**CITY OF SACRAMENTO  
DEPARTMENT OF PLANNING & DEVELOPMENT  
ZONING ADMINISTRATOR  
1231 I Street, Sacramento, CA 95814**

**ACTION OF THE ZONING ADMINISTRATOR**

On Tuesday, February 3, 1999, the Zoning Administrator approved with conditions a special permit to allow an off-site parking lot under same ownership for additional parking for an office for the project known as Z98-143. Findings of Fact and conditions of approval for the project are listed on pages 2-5.

EXHIBIT A

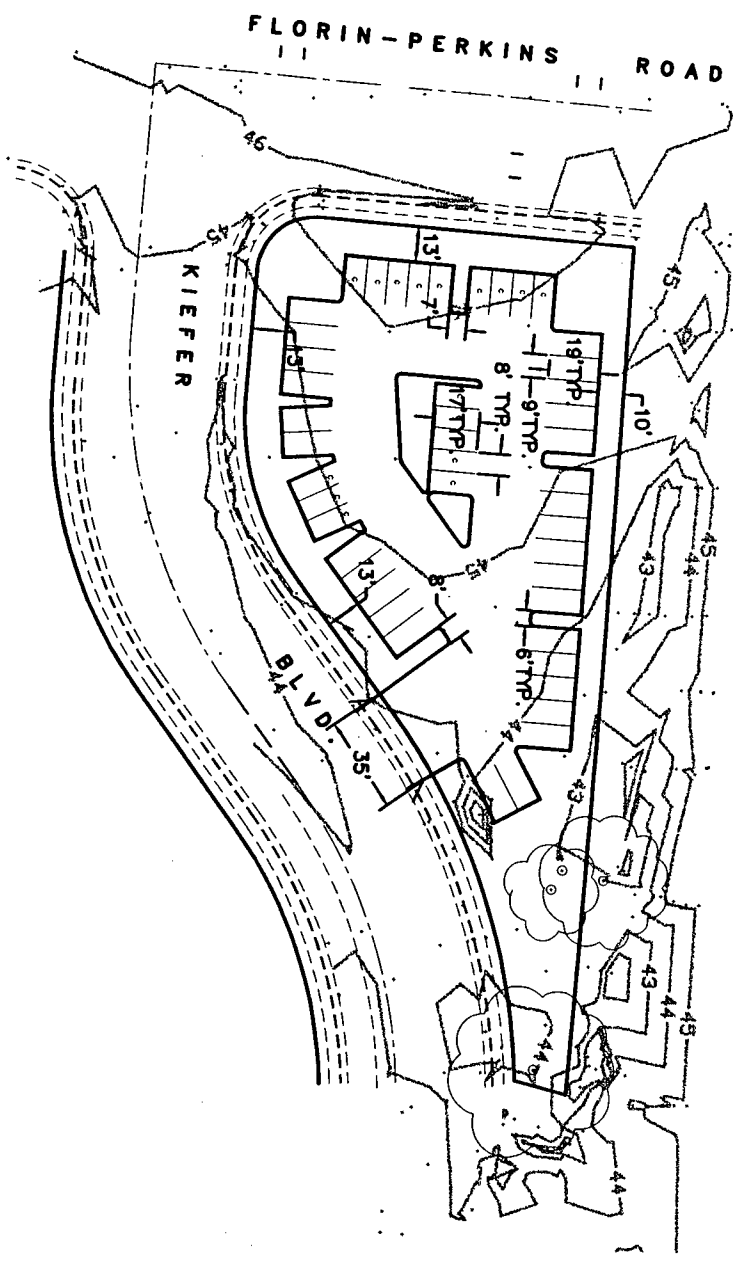
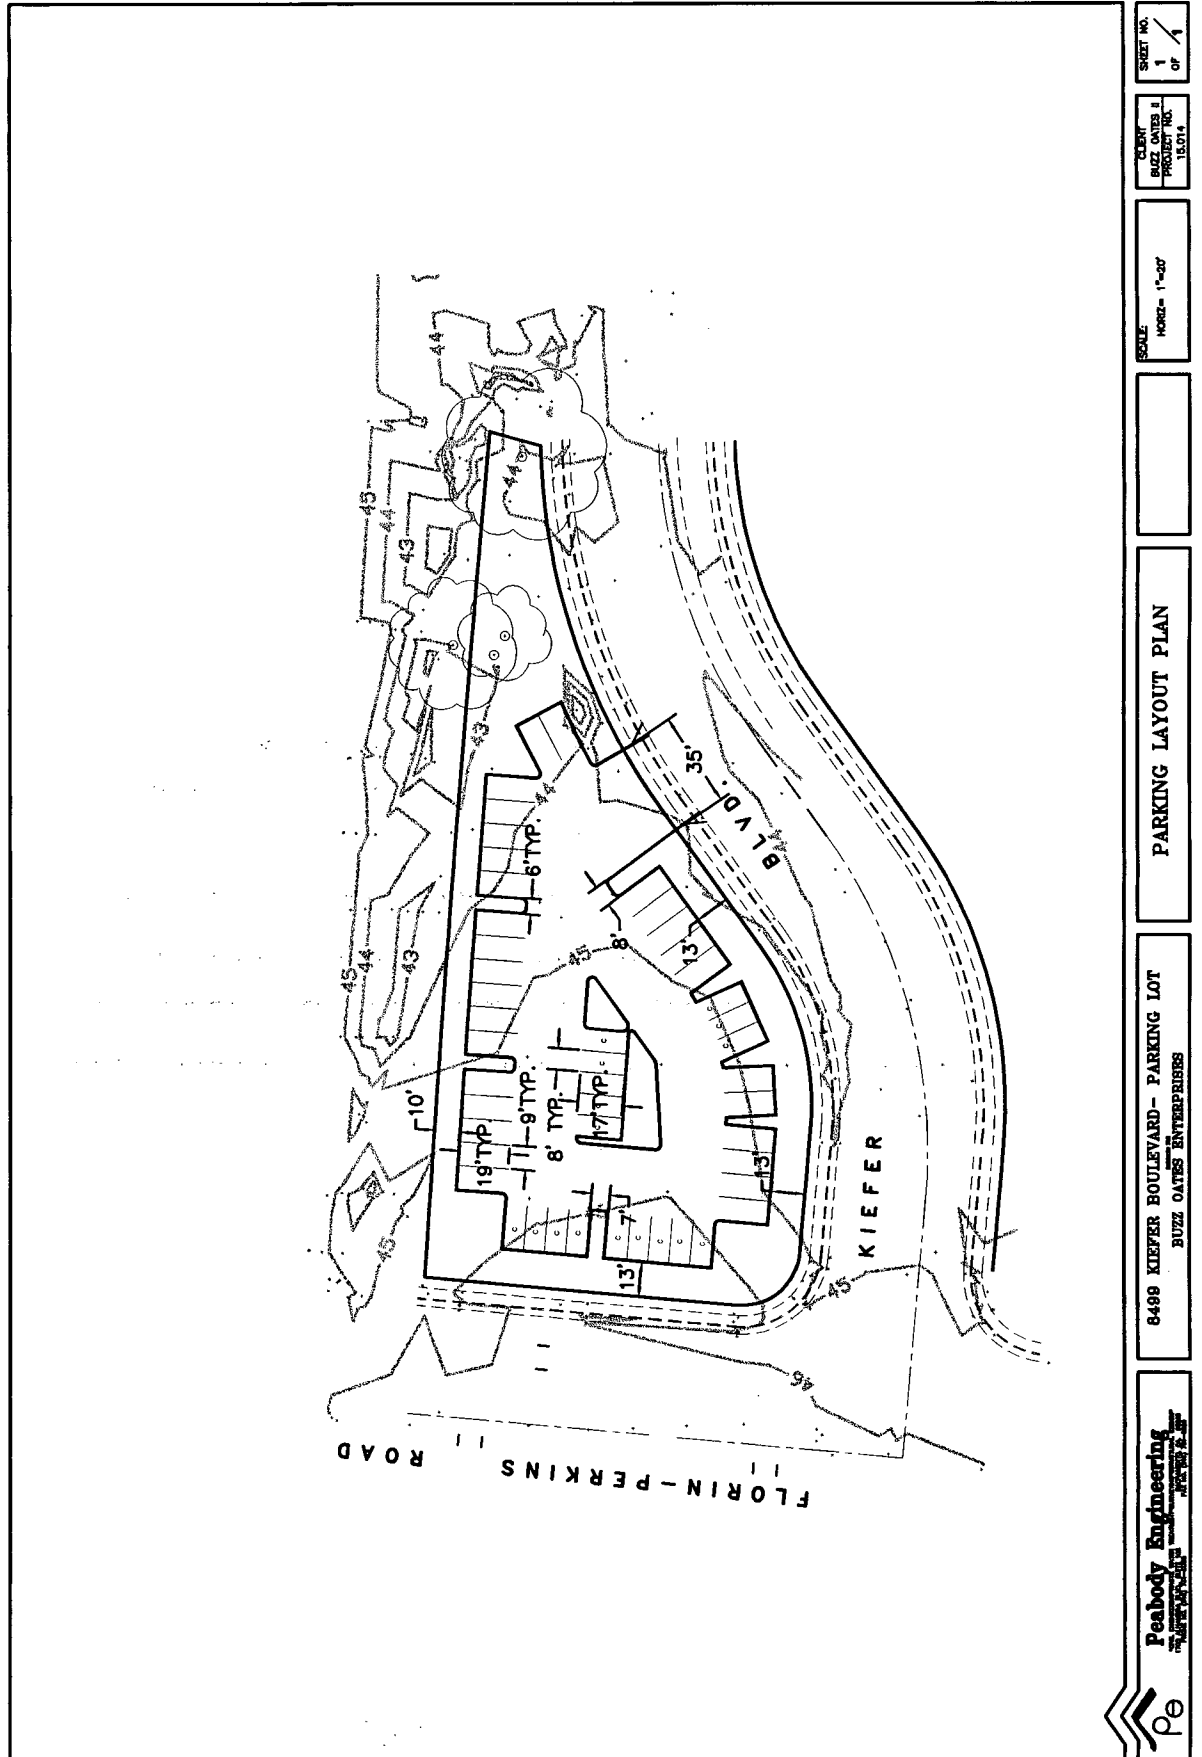
1. The applicant will provide a pedestrian walkway at the corner from the parking lot to the street crosswalk. The submitted landscape plan shall be revised to match the grading plan. The applicant shall attempt to expand the landscaped setback area along Florin-Perkins Boulevard during the parking lot revision if at all possible. The applicant shall replace the "Switch Grass" indicated on the landscape plan for the setback area with one of the following plants: Pennisetum orientale (Fountain Grass) or Agapanthus 'peter pan' (Lily of the Nile) or Liriope muscari (Big Blue Lily turf) or Dietes bicolor (Fortnight Lily).

2. The parking lot shall comply with ADA and Title 24 requirements for handicap accessible spaces.
3. The required accessible HCP parking spaces shall not be less than (2) spaces based on total proposed parking stalls shown on site plan.

4. One of the HCP parking stalls shall be served by an access aisle 96 inches wide and shall be designated as "van accessible."
5. HCP accessible path of travel to the proposed parking lot shall be shown on the site plan. The driveway shall not be used as HCP path of travel.

6. The first two stalls on the southeast side at the site entry shall be eliminated and the raised island extended into the area to provide a 25 foot throat at the entry point of the parking lot. The proposed drain inlet located within this area will need to be relocated.
